IDAP REPORT – SECTION 4.55(2) MODIFICATION

Property:	27-35 Punchbowl Road BELFIELD DA 2016/17/4
Proposal:	Section 4.55(2) Modification Application to modify basement layout, reconfiguration of commercial and residential layouts and revised external finishes schedule.
Applicant:	Eastern Pacific Design & Construct Pty Ltd
Owner:	Gazcorp Pty Ltd
Date of lodgement:	25 June 2020
Notification period:	14 to 28 July 2020
Submissions received:	Nil
Assessment officer:	M Rivera
Estimated cost of works:	\$31,463,039.00
Zoning:	B2 – Local Centre – SLEP 2012
Heritage:	Not a heritage item. Not within a heritage conservation area.
Flood affected:	Yes Yes Pre-existing variations against maximum building height (Clause 4.3) and maximum floor space ratio (Clause 4.4) provisions under SLEP 2012. No new variations proposed.
Is a Clause 4.6 Variation Proposed:	
RECOMMENDATION OF OFFICER:	APPROVAL

Figure 3: Proposed Basement Level 1 – portion showing Lift Core A, waste storage room, modified fire stairs and amended bulky goods storage comprising cleaner's room and water closet

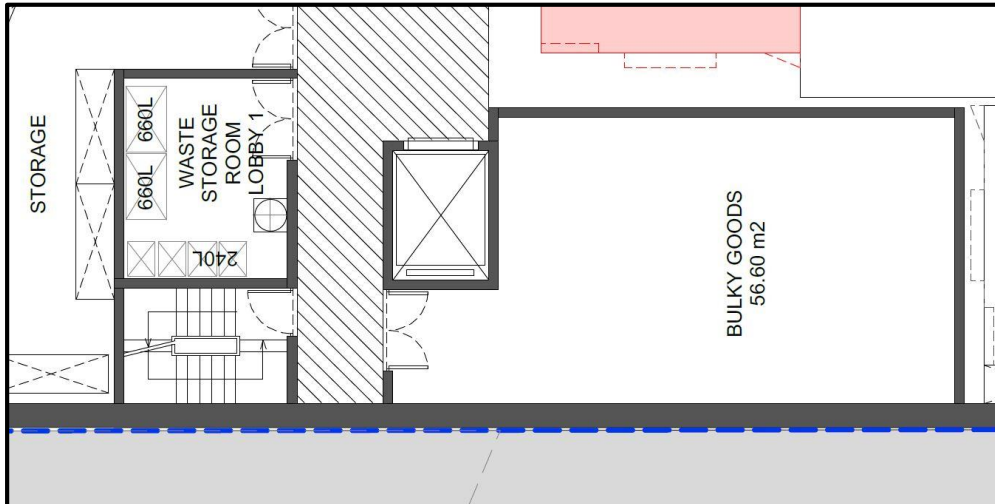
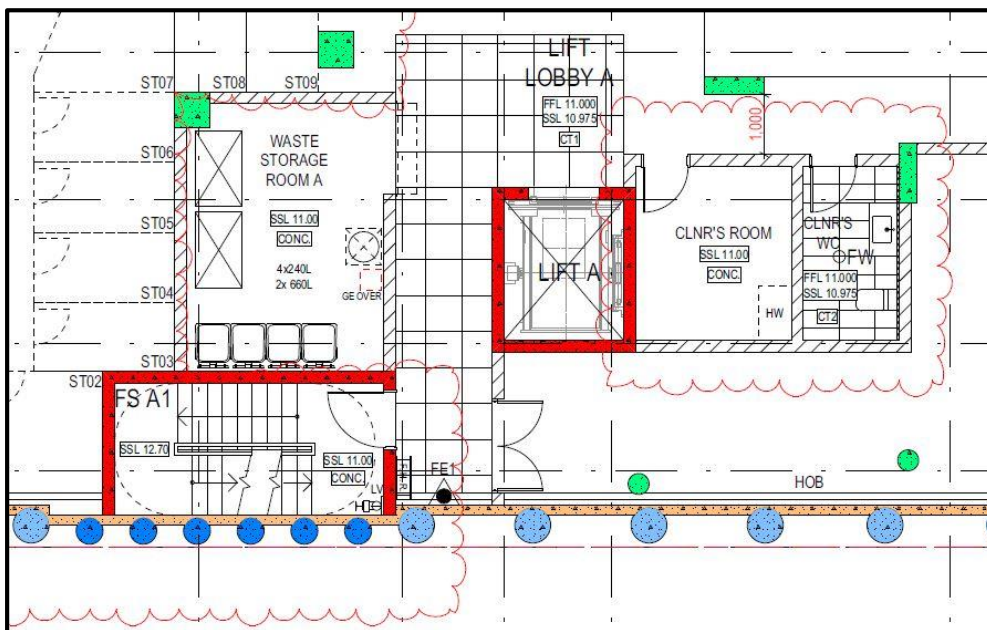
- Revised fire stairs (A,B & C) to comply with the Building Code of Australia (BCA) and relevant Australian Standard; and
- General re-arrangement of car parking spaces and storage cages to suit the changes as mentioned above. Bike parking, motor bike parking and car wash bay all remain unchanged.

- Revised Fire Stairs (A, B and C) to comply with the BCA and relevant Australian Standard; and
- General re-arrangement of car parking spaces and storage cages to suit the changes as mentioned above. The visitor parking spaces, motor bike and bike parking all remain unchanged.

Figure 5: Proposed Lower Ground – portion showing Lift Core A

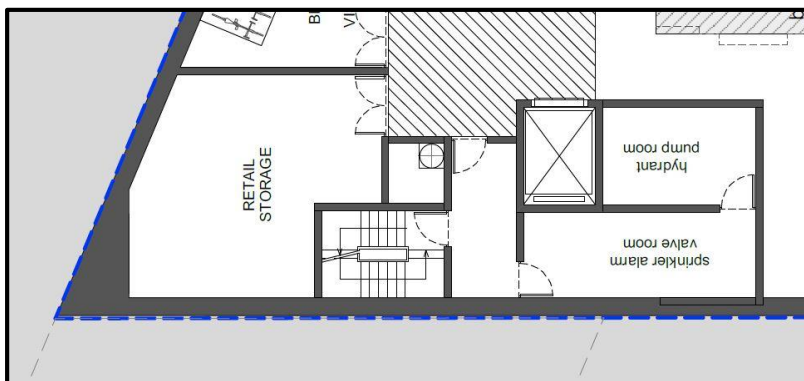
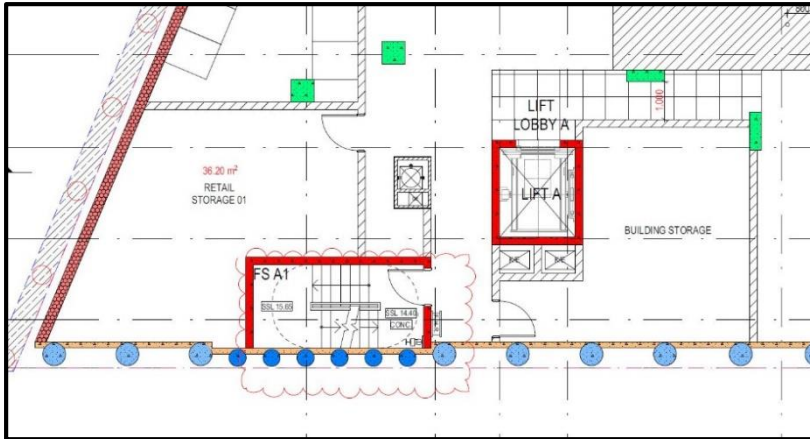
- Revised fire stairs (A,B & C) to comply with the BCA and relevant Australian Standard;
- Revised two (2) external lift and stairs on the eastern and western sides – i.e. Stair S02 and S03, Lift 01 and 02 to suit accordingly;

Figure 7: Proposed Lower Ground Level – western portion

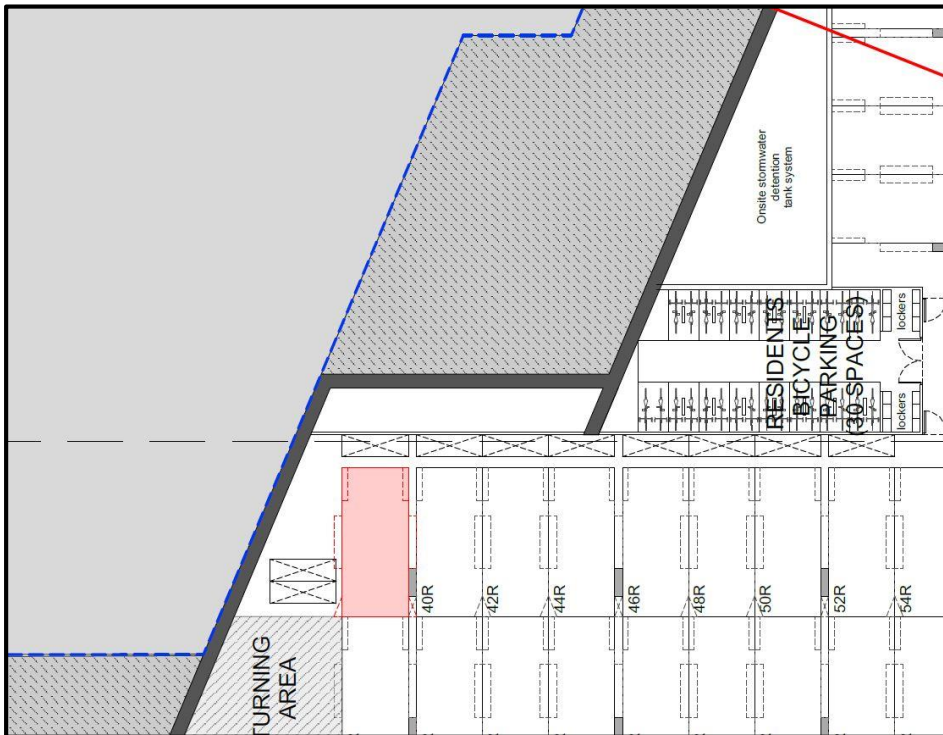
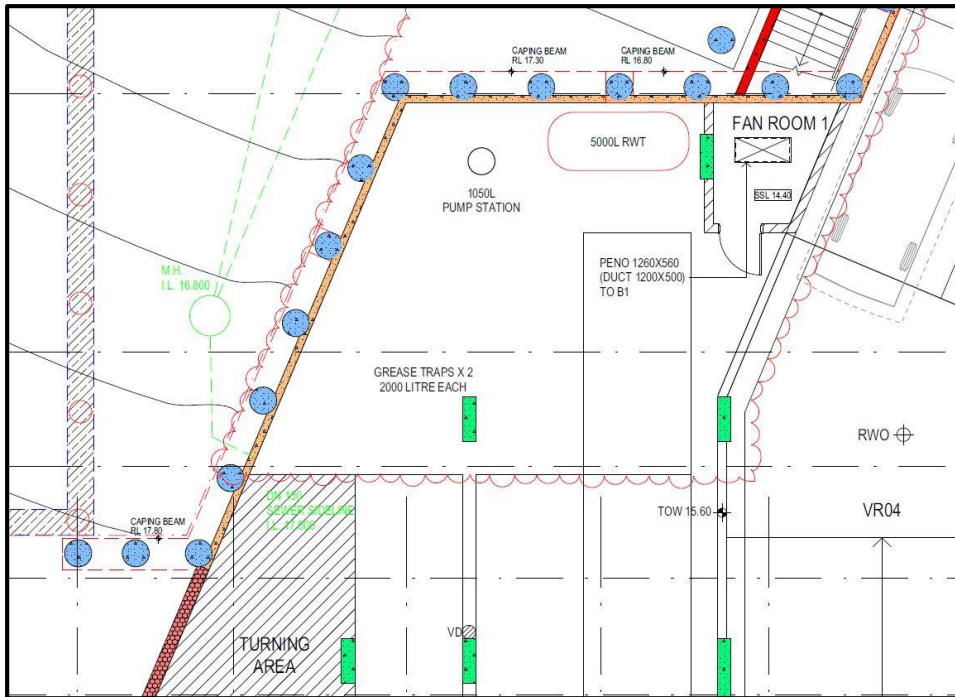
- General rearrangement of car parking spaces and storage cages to suit the changes above. All other residential units remain unchanged except for the incorporated building services risers and garbage bin cupboard re-configuration.

Figure 9: Proposed Lower Ground Level – eastern portion

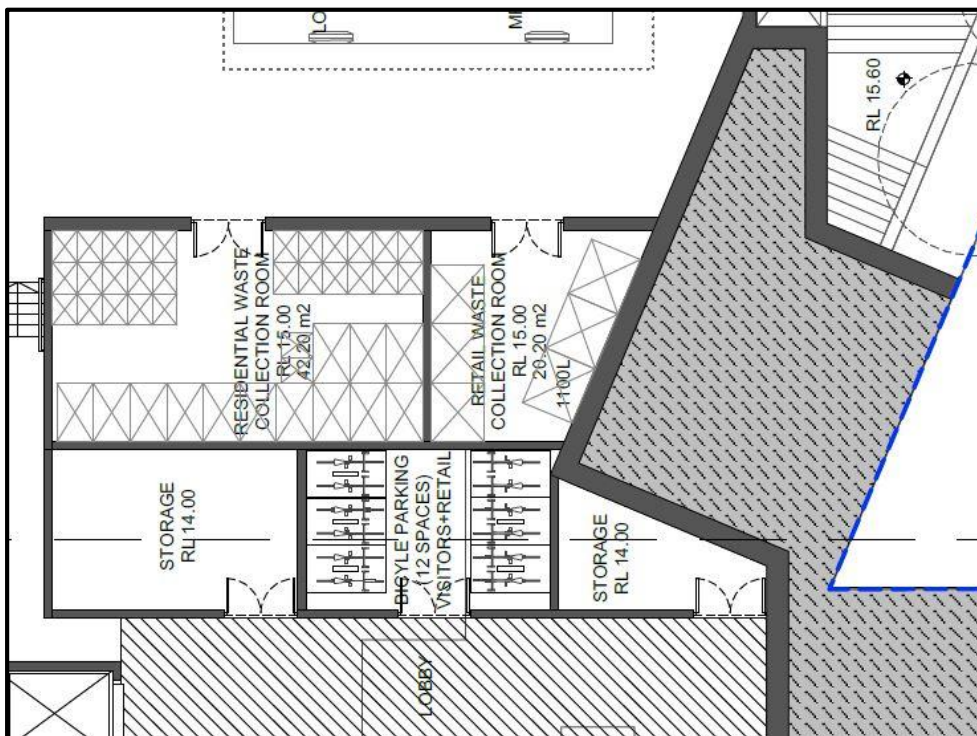
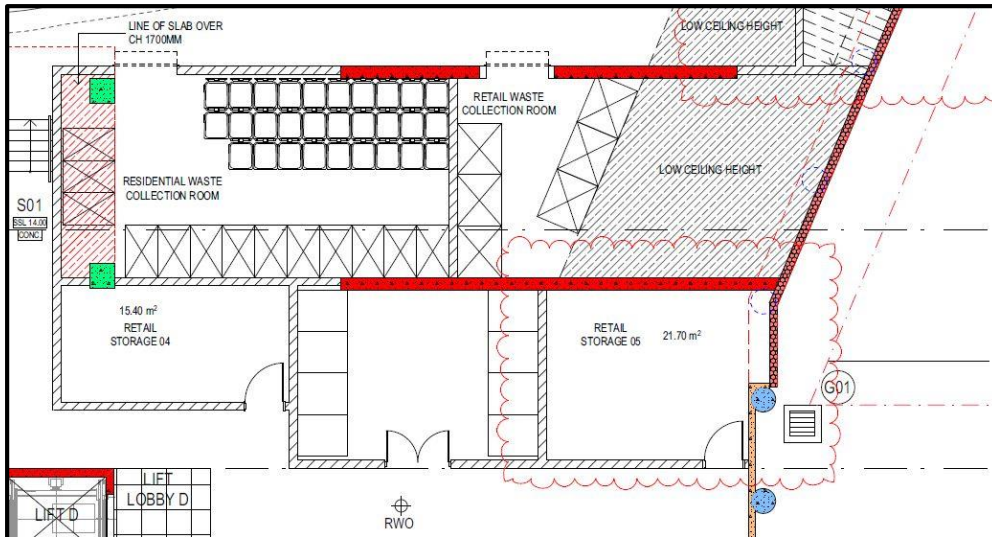
- Retail: one (1) space per 16m²; and
 - Commercial: one (1) space per 40m²; and
- Provision of additional storage areas within the eastern side (near the retail waste collection room). It is noted that this area is incorrectly hatched and annotated on the approved plans as deep soil landscaped area; however, this is in error as it is directly above the basement level (refer to Figures 8 to 9);

Figure 11: Proposed Lower Ground Level – extension of balcony in Unit E101

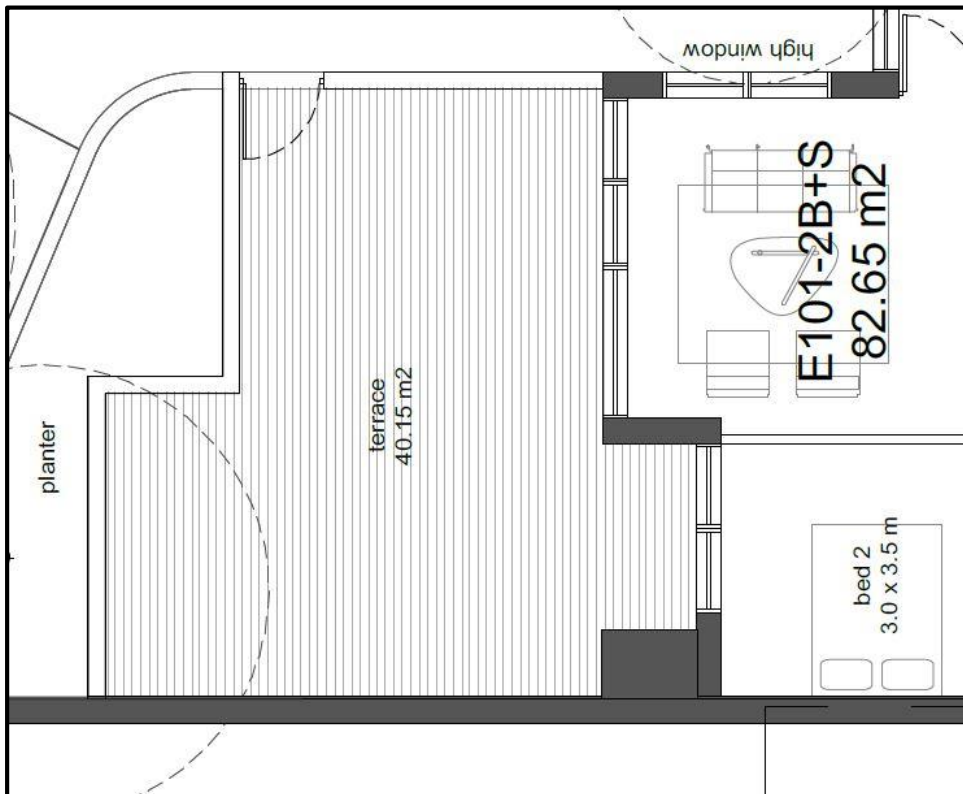
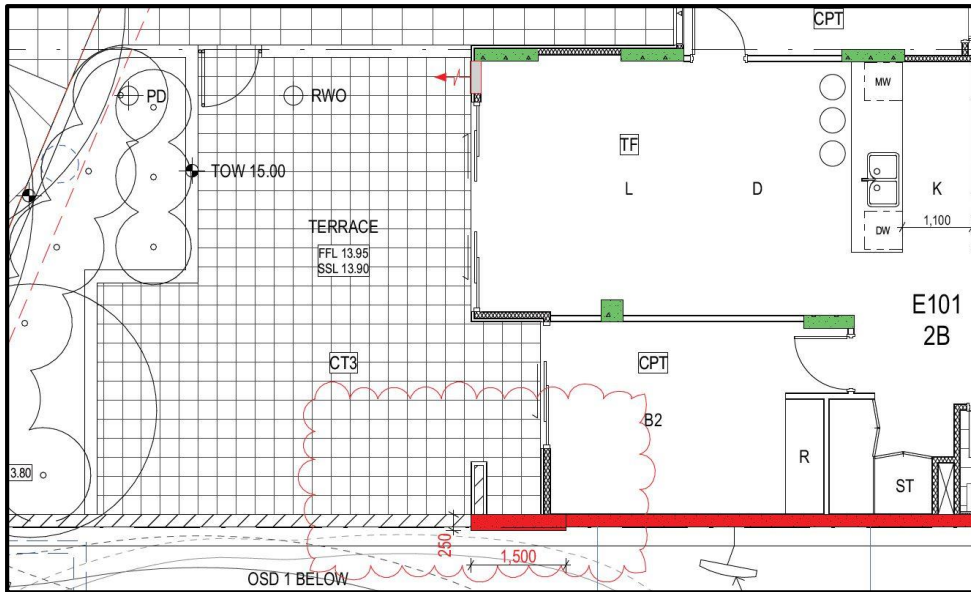
- Revised the footprint of OSD tank '2' along the north-east side (adjacent to Unit F105);
- Slight extension of the balcony area for Units E101, E103 and F101 (refer to Figures 10 to 11). It is noted that the approved plans indicated these spaces as unused spaces; and

Figure 13: Proposed Lower Ground Level – showing Commercial and Retail units

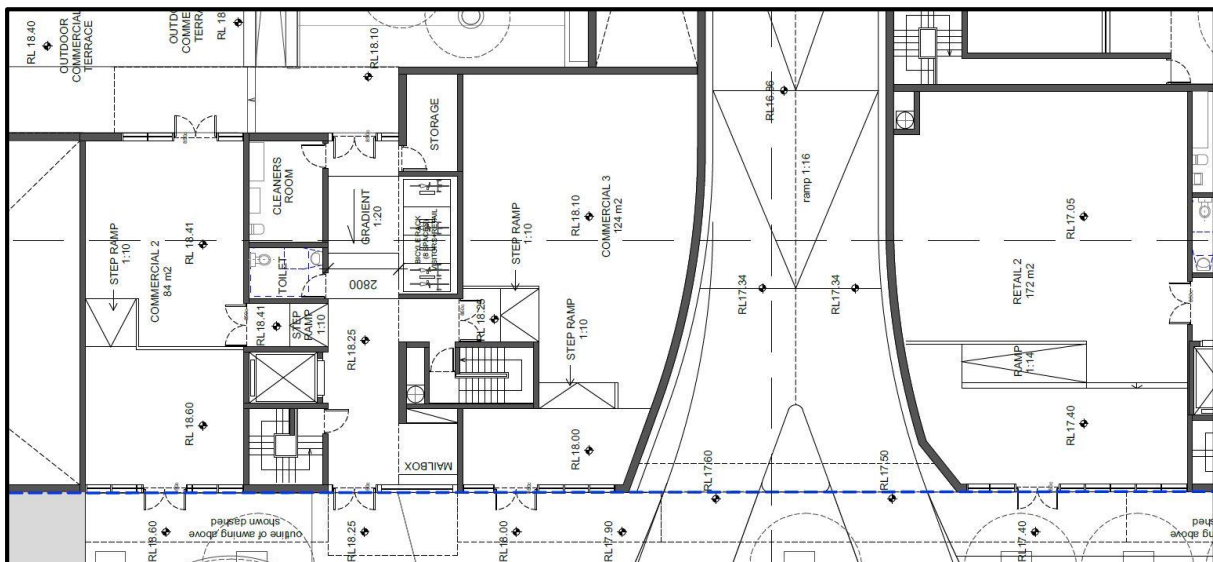
- Revised Building A, B and C entry lobbies to eliminate ramps and relocated bike racks and storages to basement levels accordingly;
- Re-configuration of retail and commercial premises internal layout and to provide each unit with its own basin benchtop and water closet (refer to Figures 12 to 13);
